Service Bulletin No. 362

MODEL E / J Series Coaches	TYPE Field Change Program	SECTION/GROUP 7-Electrical	DATE
SUBJECT DOGA WINDSHIELD WIPER MOTOR FUSE			
CONDITIONS

Figure 2.

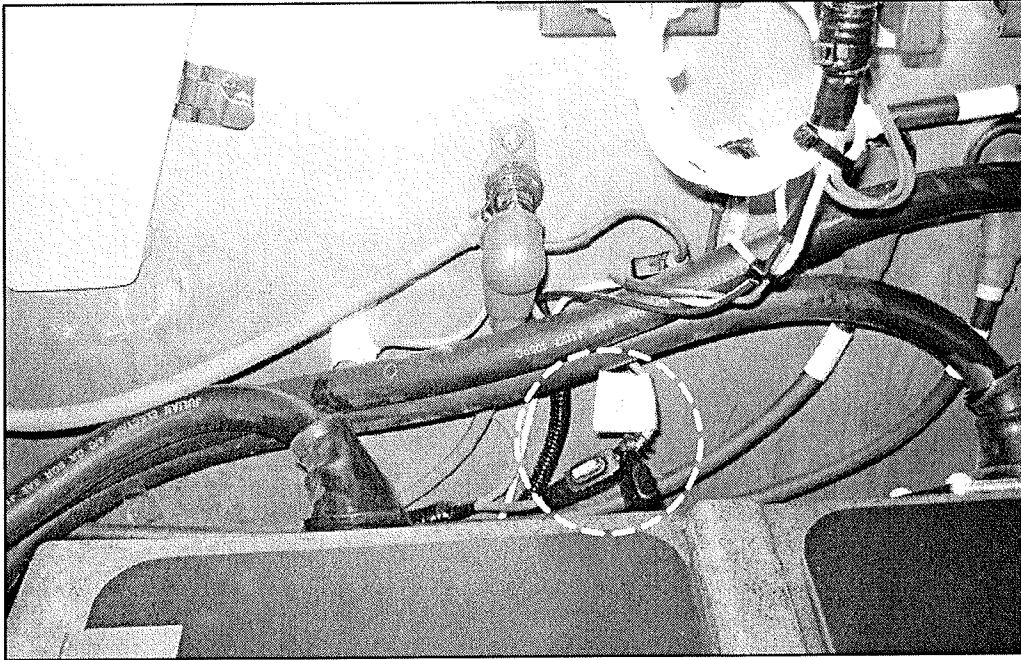
5. Locate the inline fuse routed from the 24V HOT power stud block with the decal labelled either FUSE5 15A MAX, or 30A MAX. BATT HOT (refer to Figure 2).

Figure 3.

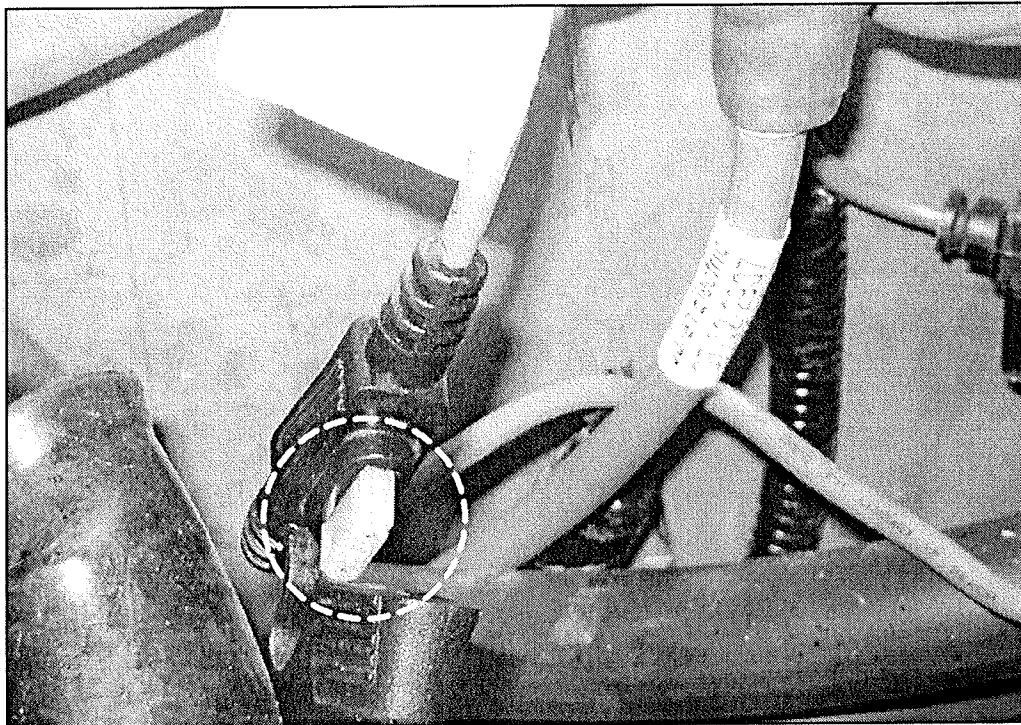
The fuse in the battery compartment for the circuit powering the wiper system may be incorrect.

6. Remove the protective flip – cap. Visually inspect to verify that a 30 AMP fuse is installed (refer to Figure 3).

If a 30 AMP fuse is installed, press to secure the flip–cap over the fuse. Visually inspect to verify that the decal text is 30A MAX BATT HOT. If not, install a new 30A decal, p/n 07-08-4061. Close the battery compartment door. Procedure complete.

If a 15 AMP fuse is installed, carefully remove the 15 AMP fuse and install a 30 AMP fuse, p/n 07-08-2176. Press to secure the flip–cap over the 30 AMP fuse. Remove the existing 15A decal and install a new 30A decal, p/n 07-08-4061. Close the battery compartment door. Procedure complete.
